Re: LBBJ Subdivision
8-15 Centennial
Lane Tax Map No.:
44.-1-1
Subdivision
ApplicationNLJ
#0001-0643

Please find below the responses to the consultant's comment made on the LBBJ Subdivision Project which proposes to subdivide a building lot (Lot 7) from the existing Lot 5 of the Centennial Golf Properties. The new lot proposes a single-family home with an on-site well and septic along with driveway access from Root Avenue.

NATHAN I. JACOBSON & ASSOCIATES, P.C. dated June 10, 2021:

AKRF dated June 10, 2021:

AREA ANALYSIS
BOUDREAU RESIDENCE
SOUTHEAST, NY

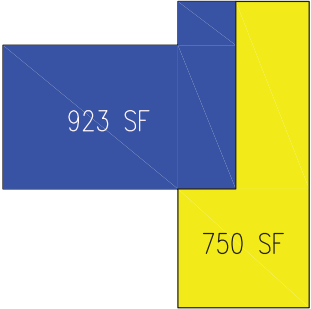
9. The Applicant requested a “waiver” from Sections 138-22 and 138-56.1 regarding the accessory apartment. However, the Planning Board is not permitted to grant “waivers” from these code sections. Instead, area variances from the Zoning Board of Appeals would be required. The Applicant should more clearly state what variances they are seeking.

- Attached to this Comment Response Letter is a Building Area Analysis prepared by LMV Architects showing the area of the 1-BR Accessory Apartment as 750 sf and the area of the primary residence as 3,000 sf. This demonstrates compliance with the code section 138-56.1 D (1) as the percentage of the 1-BR accessory apartment to the primary residence is 25%, see chart below.

Item	Use	Area (SF)
1	Primary Residence (includes drive under garage)	3,000
2	Accessory Apartment	750
3	% of Accessory to Primary (2/1)	25%

KEY
BLUE – PRIMARY RESIDENCE (3,000 SF)
YELLOW – ACCESSORY 1-BEDROOM APARTMENT (750 SF)
ACCESSORY APARTMENT IS 25% OF PRIMARY RESIDENCE
